Product Change Notification

1. ECR #: 208593
Notification #: 607

3. Series:
• ERM6 ASSEMBLY

4. Part #'s Affected
• ERM6-XX-01.5-X-DV-A-XX-K-TR

Old Design (.098" diameter kapton pad) vs. New Design (.118" diameter kapton pad)

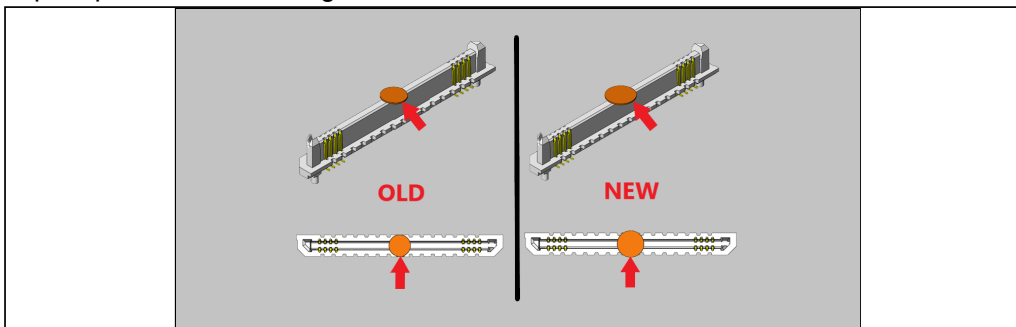
5. Description of Change:
The kapton pick and place pad has increased in diameter.

6. Method of Identifying Change
Kapton pad diameter changed from .098" to .118".

7. Reason for Change:
The change in kapton pad size is being implemented to allow the part to be inspected on our automated vision inspection equipment and will improve quality and manufacturability.

8. Impact of Change on Form, Fit, or Function:
• Form - Kapton pad size increased
